# COMMITTEE OF ADJUSTMENT

## MINOR VARIANCE REPORT

APPLICATION: A/048/2025

**A/048/2025 – 1547 Bayview Road (West District) (OP Designation: Low Density Residential)**

*1547 Bayview Road – Proposed Front Elevation*

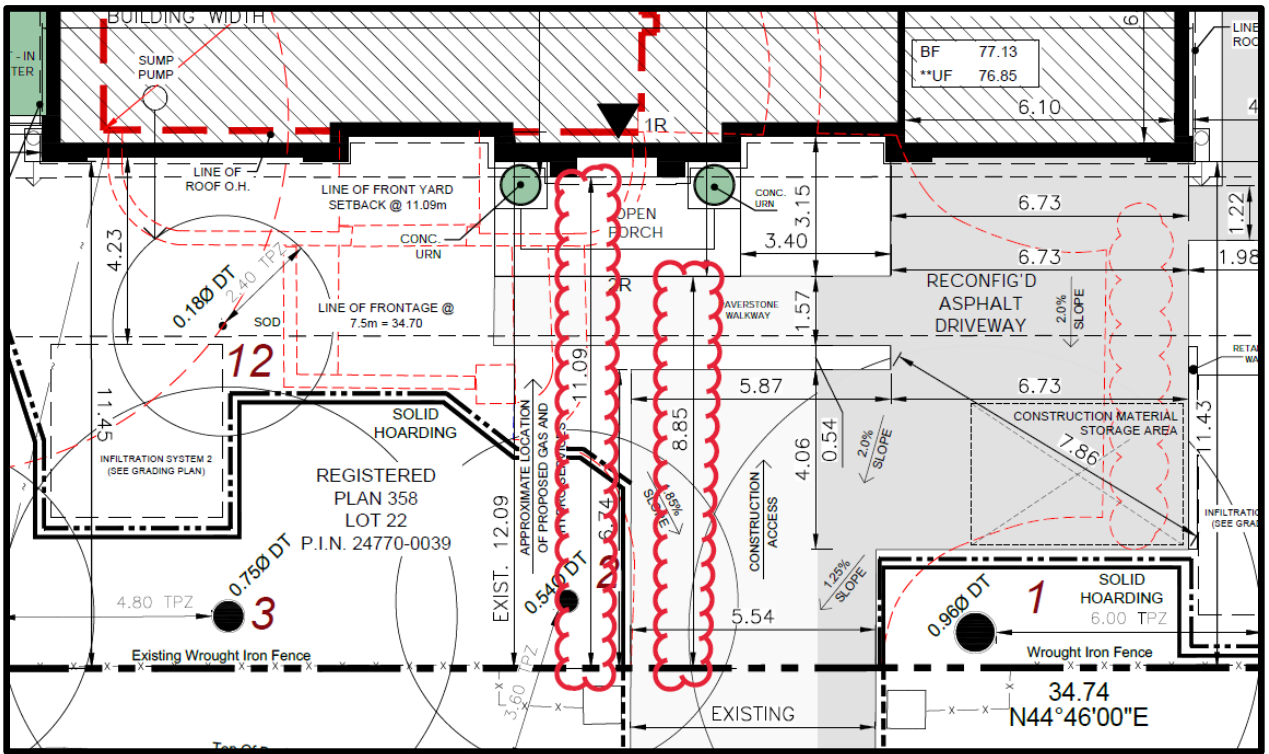
There have been no measures taken to mitigate some of the potential massing and scale impacts along the front façade, such as the second storey being incorporated into the roofline, stepbacks along second storey to reduce the overall floor area, or façade articulation. Additionally, the inclusion of non-functioning aesthetic dormer windows into the roof along the front façade makes the dwelling appear to be 3-storeys in height, exacerbating the perceived height from the public realm. As seen in the above photos, the single detached dwelling abutting the subject property to the east has been carefully renovated, incorporating a majority of the second floor into the roofline along the Bayview Road frontage, making it appear considerably smaller in massing and scale than the proposed development. The subject proposal has attempted to mitigate some of the impacts on neighbouring properties, but the magnitude and cumulative impacts of variances being sought still result in a development that is not desirable or appropriate given the existing neighbourhood character.

In Staff's opinion, the proposed floor area and lot coverage increases, large open-to-below areas at the front and rear of the dwelling, along with some of the chosen exterior façade design elements, have not been properly considered when examining it against the existing character of the stable residential neighbourhood in which it is located. As such, the proposal results in a development that appears to be substantially larger than those around it and would result in negative cumulative impacts on the surrounding neighbourhood. On this basis, it is Staff's opinion that variances #1, #2, and #3 do not maintain the general intent and purpose of the Official Plan as these variances contribute to a proposal that would not maintain nor protect the character of the existing neighbourhood.
